T.I. no.: 2018 - 06 Updated: -	Topic: SC Soul Software 3.0.2
--	--------------------------------------

Date: 28.03.2018	Priority	Need for action
Affected machines: SC Soul	High	As soon as possible
From serial number: 1813.../	X Medium	X On next visit to the machine
As of date: -	Low	FYI only

NEW FUNCTIONS AND IMPROVEMENTS

Activating the milk system

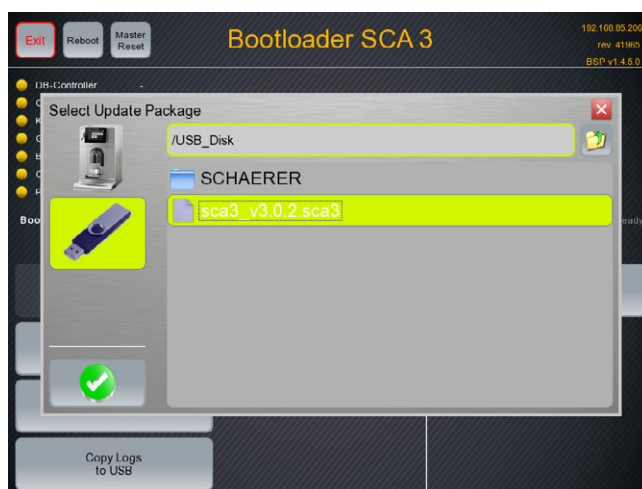
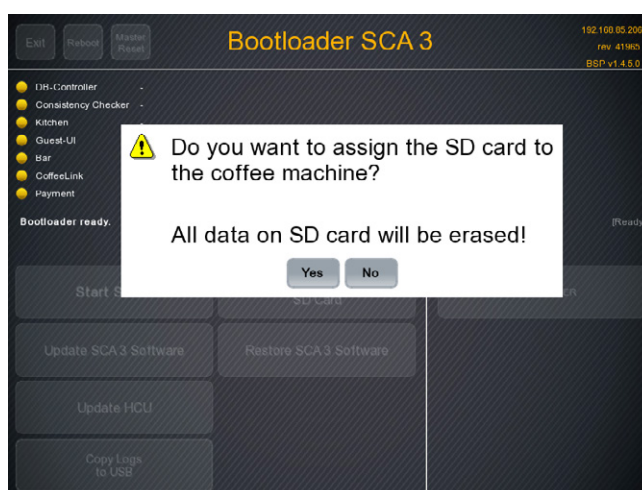
The handling for activating the milk system has been revised. The following parameters are now available in the "Milk system" menu.

Activating the milk system after cleaning

- Ask - after cleaning is complete, it asks whether the milk system should be switched on or off.
- Automatic activation - milk system is activated after cleaning.

Activate the milk system when the machine is started.

- No action - setting from before switch-off is adopted.
- Ask when deactivated - query if the milk system was deactivated before machine start.
- Automatic activation - milk system is activated when machine is started.

Procedure for a defective display from 3.0.2

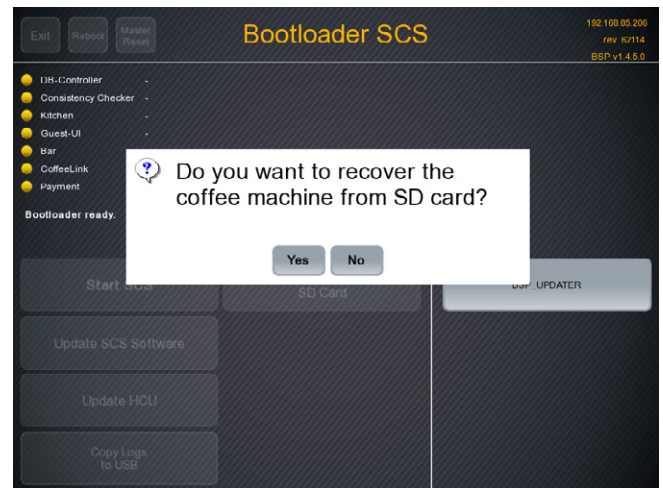
If a display for which 3.0.2 or higher was installed must be replaced by an older display, proceed as follows.

1. Remove defective touch panel and install replacement panel.
IMPORTANT: Leave SD card in the replacement panel! Do not yet replace with card from the defective touch panel!
2. Switch on the machine.
3. Machine starts and remains in bootloader.
4. Activate "Yes" field -> SD card from replacement panel is formatted. **Note:** No data is lost since this SD card is still empty.
5. Then start the software update.
6. Wait until the update has run and the machine has restarted. When commissioning comes on, switch the machine back off.
7. Insert SD card from the defective touch panel into the new touch panel and remove USB stick. Then switch the machine back on.

8. Machine starts and remains in bootloader again.
9. Confirm "Yes" field.
The software which was previously installed on the machine is now reinstalled and the last state of the database is restored.

10. Wait until the machine restarts and the guest UI is displayed.
Note: Commissioning does not have to be run (certain cleanings might have to be done). The version can be checked in the management UI.
Note: A higher version than 3.0.2 can now be installed again.
